UNITED STATES PATENT AND TRADEMARK OFFICE

APPLICATION NO.	FILING DATE	FIRST NAMED INVENTOR	ATTORNEY DOCKET NO.	CONFIRMATION NO.
10/594,907	08/07/2008	Takeshi Sakamoto	46884-5519 (232060)	8322
55694 7590 11/09/2011 DRINKER BIDDLE & REATH (DC) 1500 K STREET, N.W. SUITE 1100 WASHINGTON, DC 20005-1209			EXAMINER JUNG, MICHAEL	
			ART UNIT 2895	PAPER NUMBER
			NOTIFICATION DATE 11/09/2011	DELIVERY MODE ELECTRONIC

Office Action Summary

Annotated Drawing 23 of Naoki

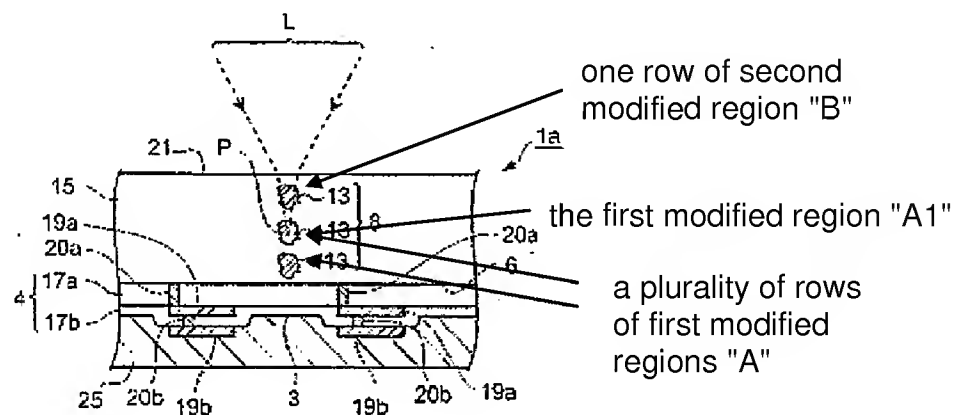
Regarding claim 1, Naoki teaches a laser processing method (see Annotated Drawing 23 of Naoki) of

irradiating a substrate 15 (para [0075]) having a front face 6 (para [0052]) formed with a laminate part 4 (para [para [0022]]) including a plurality of functional devices (para [0072] - "...the semiconductor layer laminated for elements exists in many cases...integrated circuit elements..."; see Annotated Drawing 23; see also para [0052].) with laser light L ("L" in Drawing 23; para [0022] discloses that "L" stands for laser beam.) while locating a light-converging point P of the laser light (see Annotated

Drawing 23 above) within the substrate 15 (para [0331]) so as to form a modified region 8 (para [0073] - "cut starting point domain") which functions as a start point for cutting within the substrate 15 along a cutting line (a line that overlaps the melting treatment regions 13 in the thickness direction of the substrate 15; para [0076] - "...If the crack by the melting treatment area 13 is grown up into the thickness direction...the wafer 1a can be also separated.) of the substrate 15,

a first forming step of forming a plurality of rows of first modified regions A (see Annotated Drawing 23) along the cutting line; and

a second forming step of forming at least one row of a second modified region B (see Annotated Drawing 23) along the cutting line at a position between the first modified region A1 closest to a rear face 21 of the substrate 15 and the rear face 21 (see Annotated Drawing 23), so as to generate a fracture extending along the line to cut (para [0076] - "...If the crack by the melting treatment area 13 is grown up into the thickness direction...the wafer 1a can be also separated...") from the second modified 13 region to the rear face 21;

as a result of the second forming step, generating a fracture extending along the cutting line from the second modified region 13 to the rear face 21.

Regarding claim 3, Naoki further teaches the first and second modified regions A, B that are successively formed one by one from the side farther from the rear face 21 while using the rear face 21 as a laser light entrance surface (see Annotated Drawing 23).

At the time of the invention, it would have been obvious to one of ordinary skill in the art to employ a laser light having a greater energy when forming the first modified regions than when forming the second modified regions as taught by Naoki, so as to keep the size of the modified regions relatively similar to each other as shown in Annotated Drawing 23.

Regarding claim 14, Naoki discloses the light-converging point P that is located in about half way in between the substrate in the substrate thickness direction. Since Naoki teaches that the substrate 15 can have various thicknesses such as 100 microns (para [0033] and [0034]), it would have been obvious to one of ordinary skill in the art that the light-converging point P of the laser light L is located when forming the second modified region 13 closest to the rear face 21 of the substrate 15 is distanced from the rear face 21 by 20 micron to 110 micron, and a position where the light-converging point P of the laser light L is located when forming the second modified region second closest to the rear face 21 of the substrate is distance from the rear face by 140 microns or less (see Annotated Drawing 23).
